Facility Review

Flathead Indian Irrigation Project

Pumping Plants

Photograph 25: Flathead Lake Pumping Plant synchronous motor excitation system (Multilin).

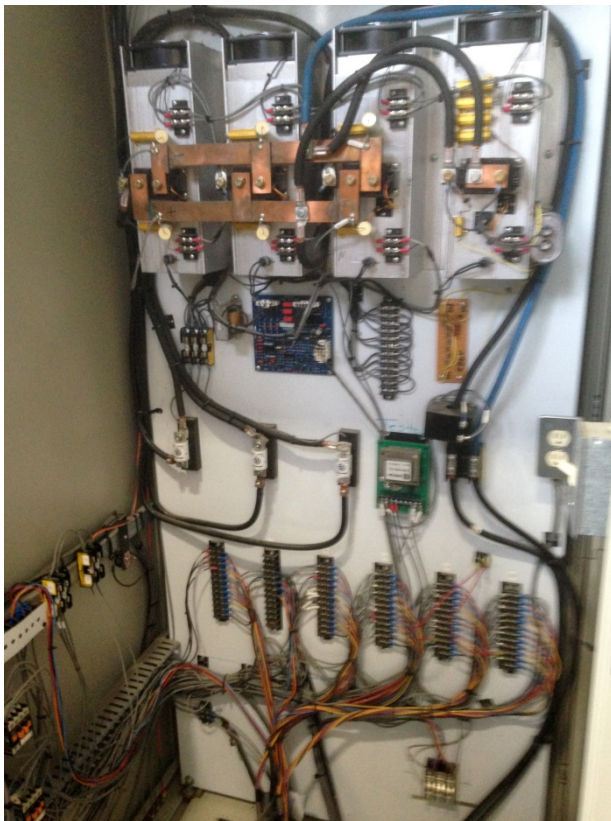
The synchronous motor excitation system (Multilin) appears to be dated from the 1990s and is relatively new and in good condition. Note: If recommendations are followed to install VFD and induction motors, then the excitation system is no longer required.

Photograph 36: Wiring to the pump timer relay.

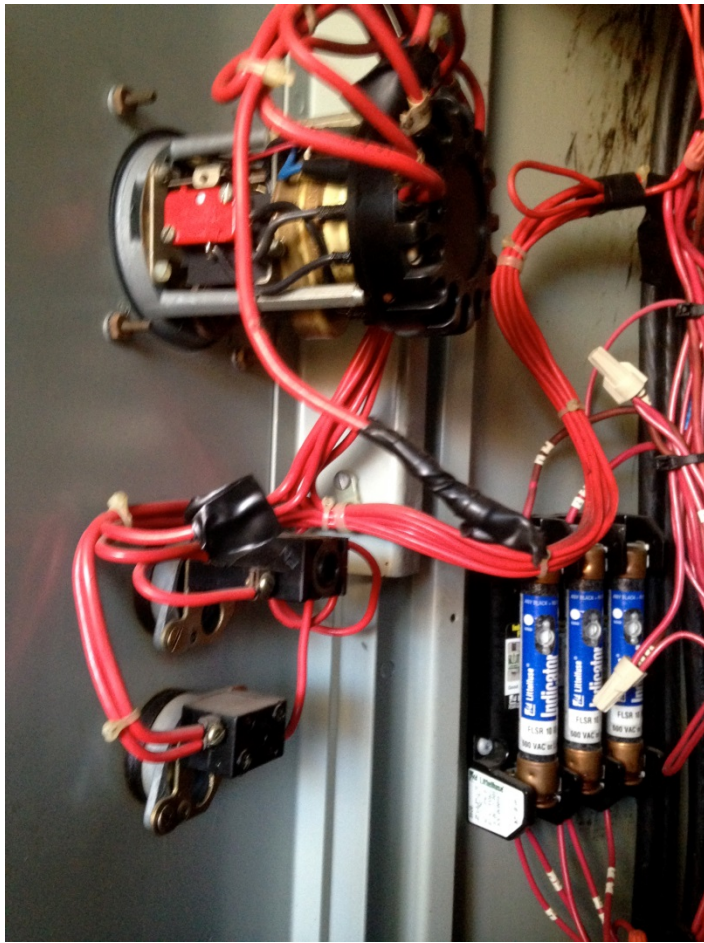
The Reavis Pumping Plant is capable of operating, with the exception of the pump timer relay wiring. Fixing it requires locating the control system schematic and performing basic electrical diagnostic. Photograph 36 shows wires that have been removed and taped off, which prevents proper operation of the pump timer. Repairs should only cost approximately \$200.

Wires that have been taped off. Timer function is disabled.
